**CHARTER TOWNSHIP OF BRIGHTON
BOARD OF TRUSTEES
4363 BUNO ROAD
BRIGHTON, MI 48114**

**JANUARY 14, 2026
SPECIAL MEETING
6:30 P.M.
(810) 229.0560**

Organization of Woodland Lake (OWL)

RZ #25/01 FOR THE COVE AT WOODLAND LAKE

OVERALL SITE MAP

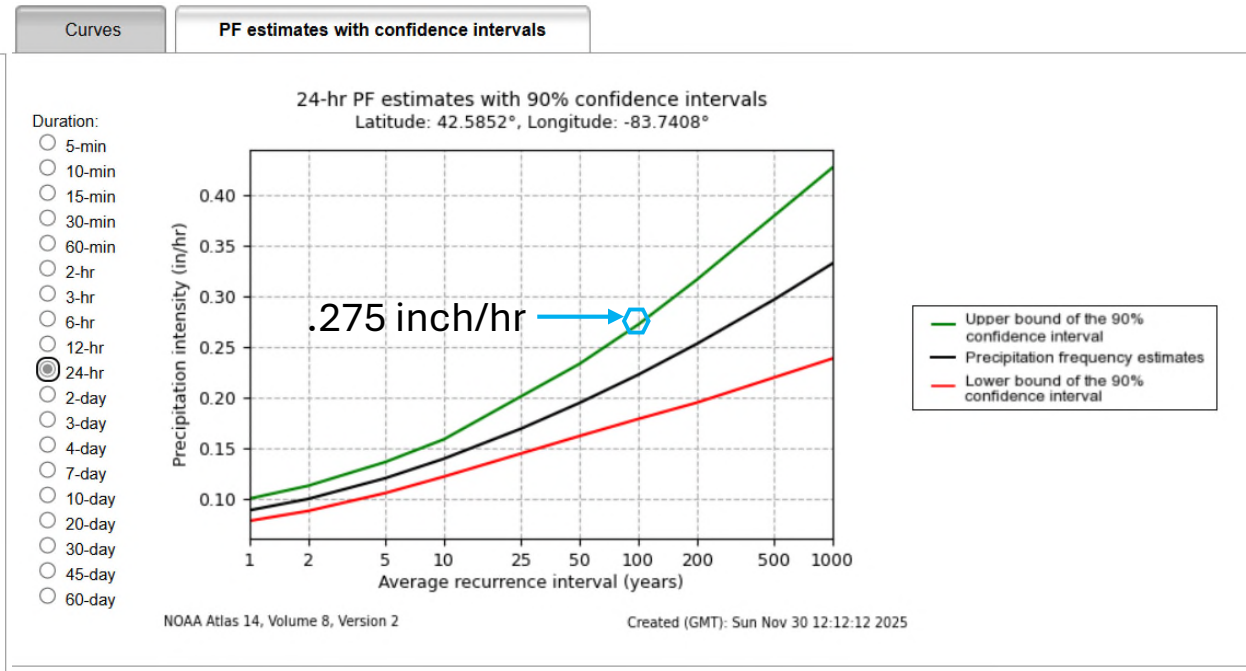
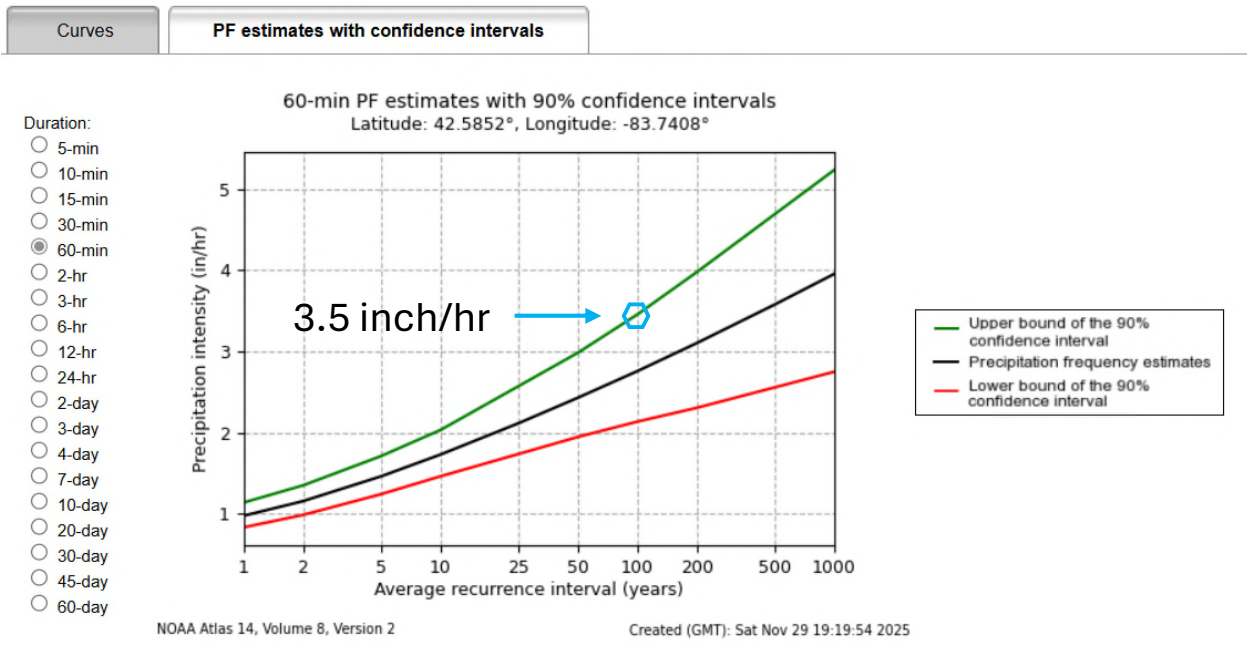
Note: The **Baseline plan** proposed has **3,400** feet of road length. **4.5X master plan rqmts.**

- Smaller lots drive higher impervious surfaces
- ~4x length of roadway maximum drives excessive impervious surface
- 750 foot of roadway = 9.375 lots. +30% => 12.2 lots, not 40
- Shorter roads => less acreage for stormwater accumulation
- More people add tire wear, fluids, exhaust and total pollution
- More lots drive higher impervious surfaces and flows

These PUD deviations are hugely detrimental to flooding and lake contamination, violate Master Plan requirements

Seems we are squeezing every residence in possible, not trying to protect our lakes per Master Plan guidance

R2 Modified strawman

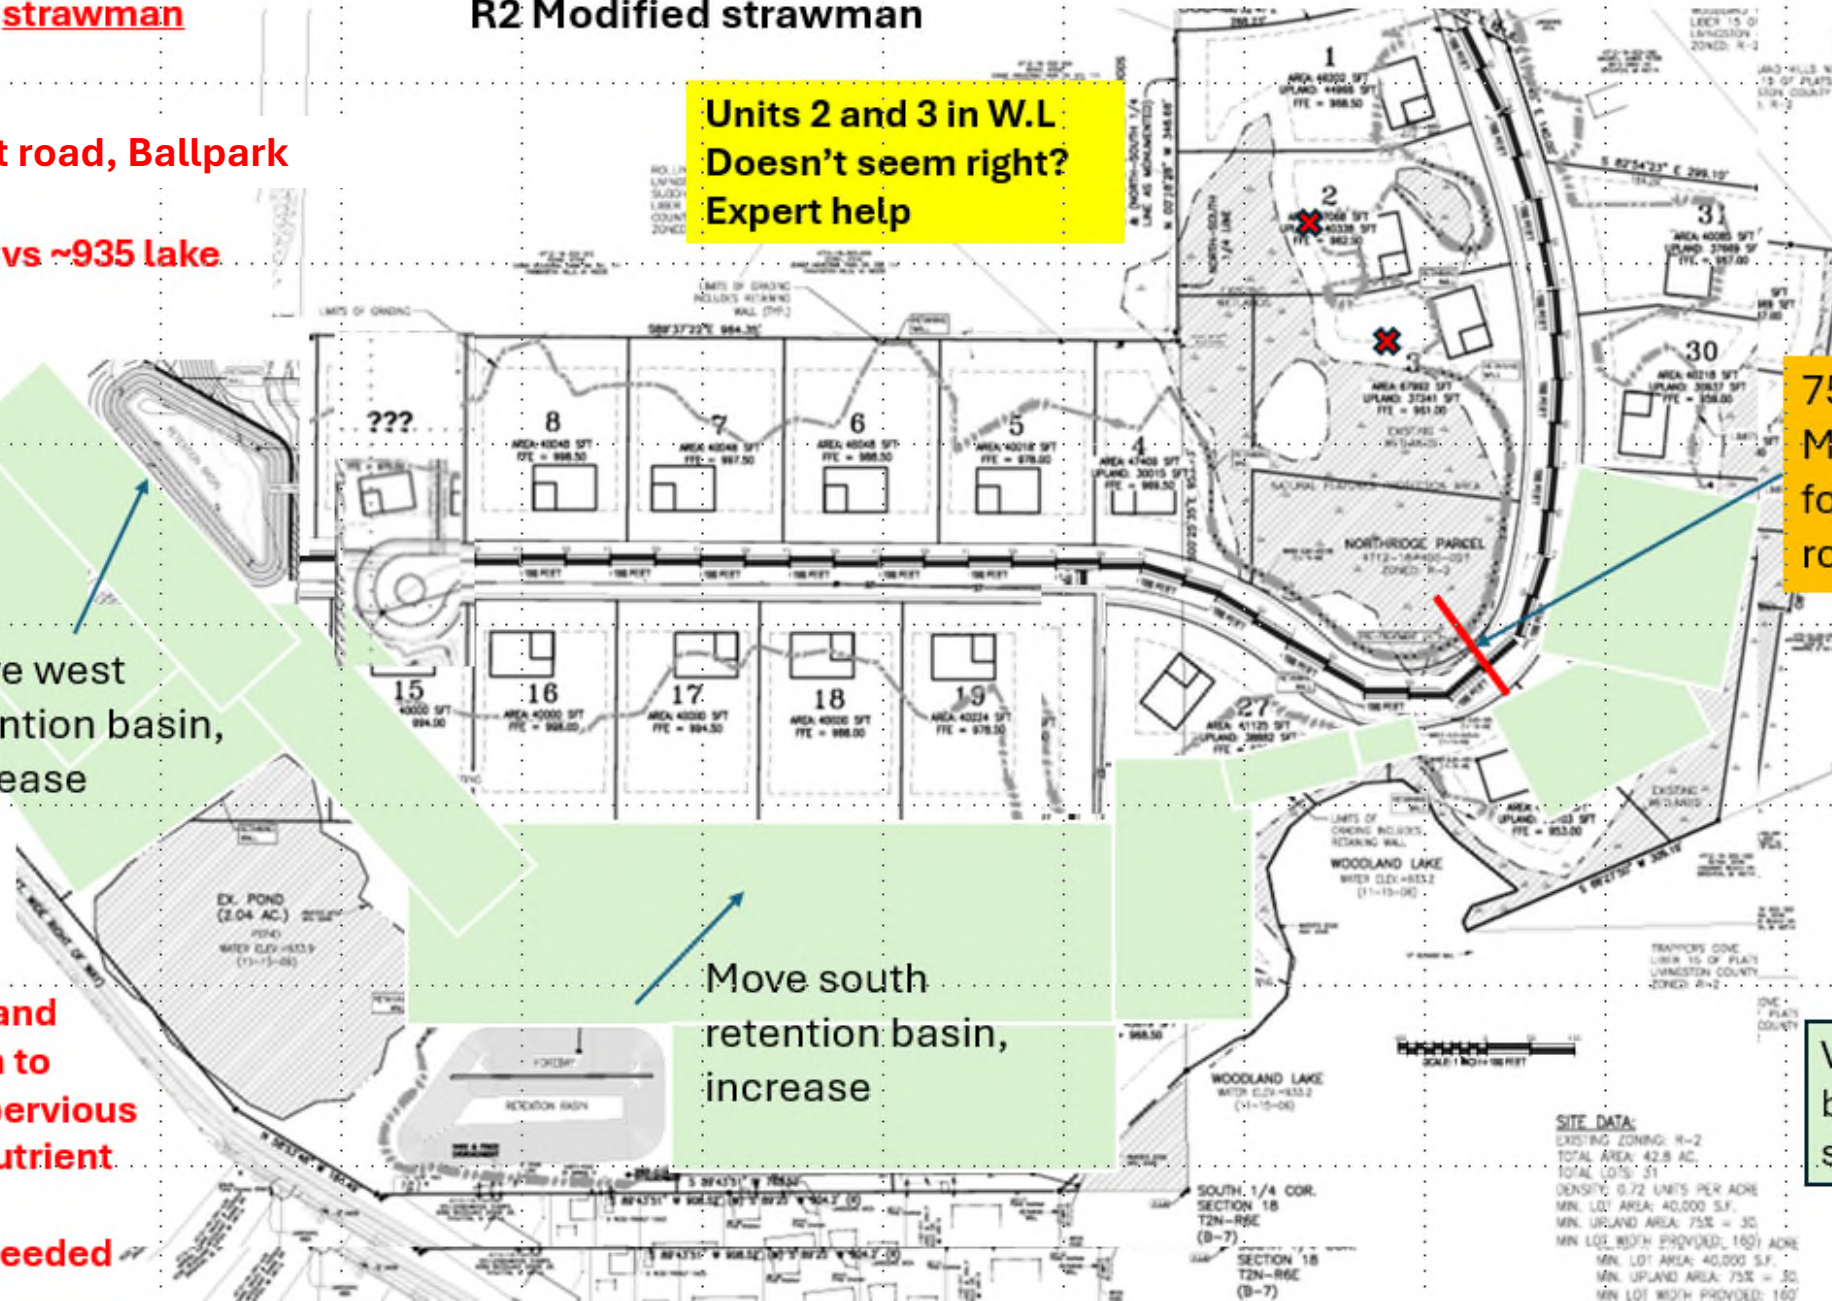
Units 2 and 3 in W.L.
Doesn't seem right?
Expert help

Move west
retention basin,
increase

Move south
retention basin,
increase

Work lot sizing and
other mitigation to
enable 0.25 impervious
max, net zero nutrient
change
Env Egrg Help Needed

Vegetative
buffers and
swales

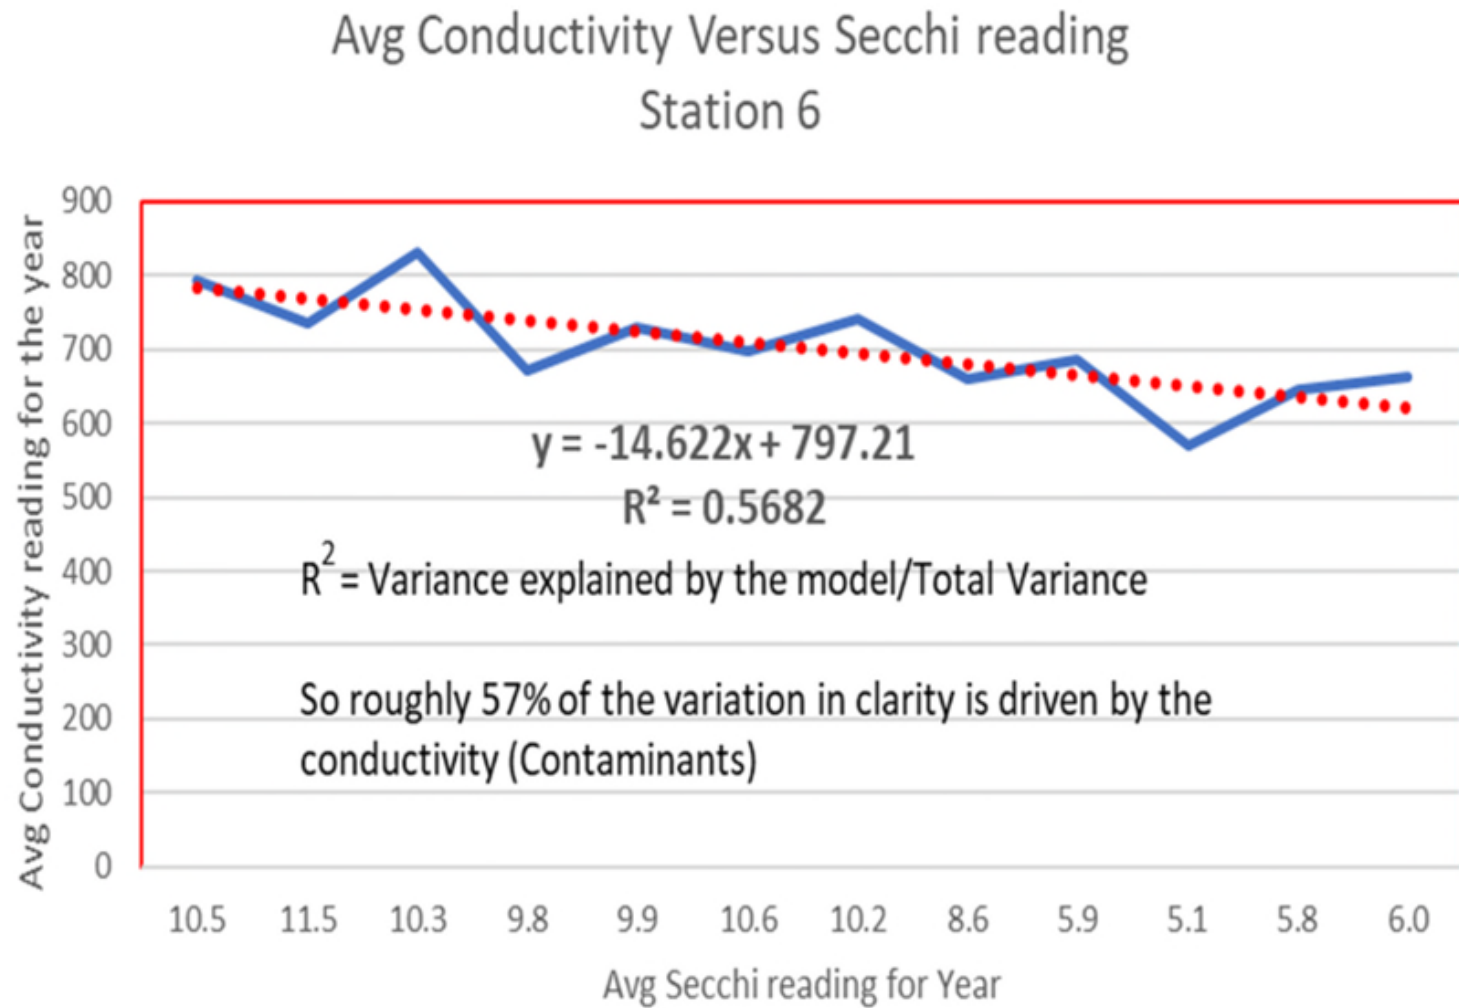
Current bottom of retention basins are between 931 and 945 feet above sea level

Lake at 935, need bottom of retention basins over ~942 to allow infiltration

Road length 750 max
Lot sizes 40K sqft
0.15 build density
160 ft min width lot

Protect flooding pond 100 year, 1 hour and 24 hour

Slow runoff, add vegetative buffers to safely filter any potential overflows

Concept suggestion only (Need neutral 3rd party environmental Engineering guidance):

Baseline layout, modified to **fit at 960 ft elevation**. Reduce road length further?? **1 acre lots, .15 max lot coverage**

Get to **0.15-0.25 C factor**, then **oversize flooding and nutrient absorption safety factors. 960 ft elevation enabler?**

Eliminate sidewalks, reduce roadway and increase lot sizes until 0.15-0.25 C value achieved (W/ neutral Enviro Engrg)

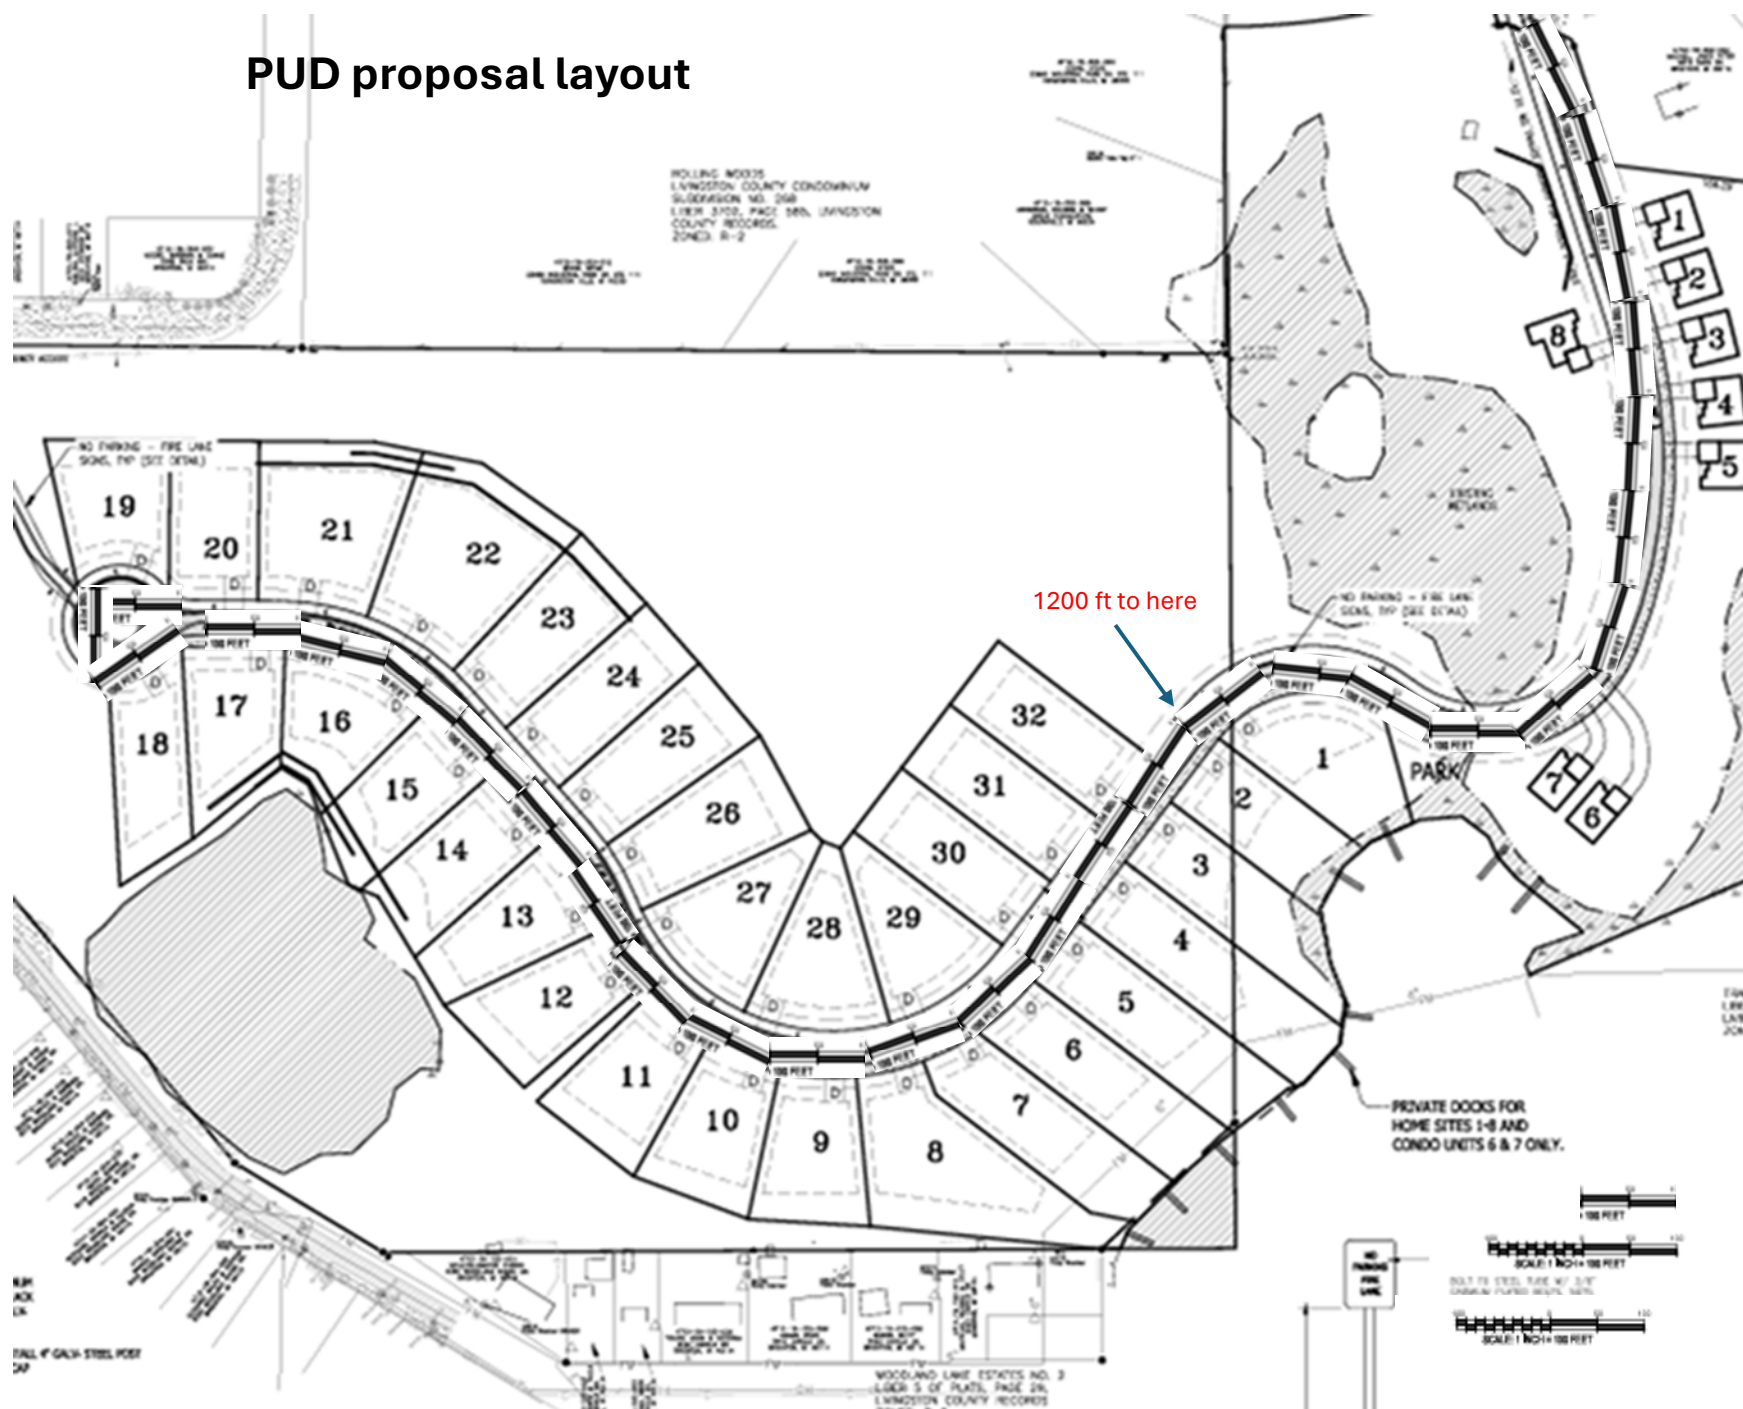
9.375 times 1.3 = 12.2 lots

R2 Baseline plan

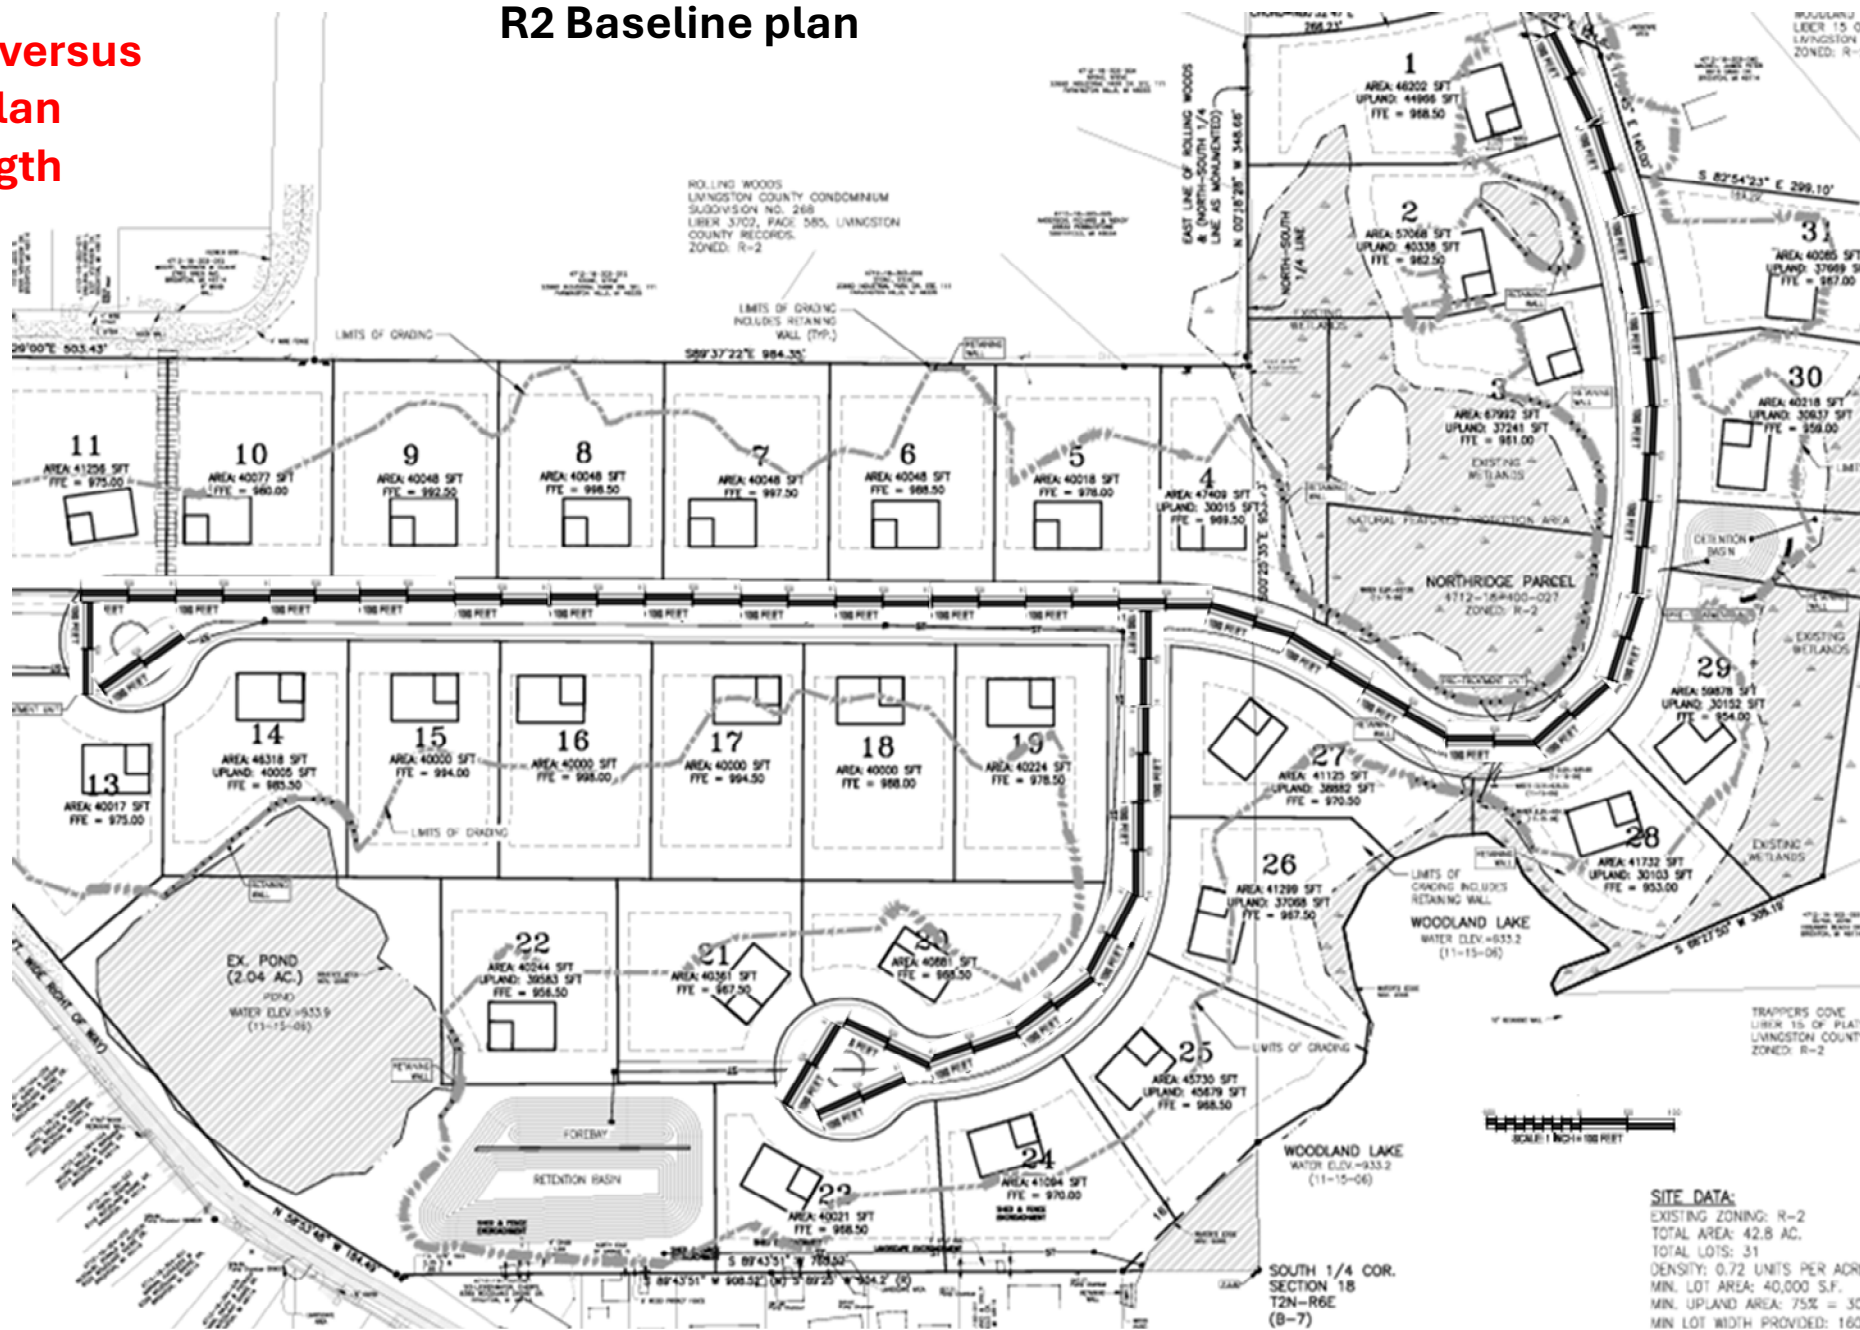
2,888 ft to
culdesac
Versus 750
feet per
Master Plan

**3,400 ft total versus
750 Master Plan
Roadway length**

1250 ft to intersctn
1250 ft after intersctn
900 ft lwr culdesac
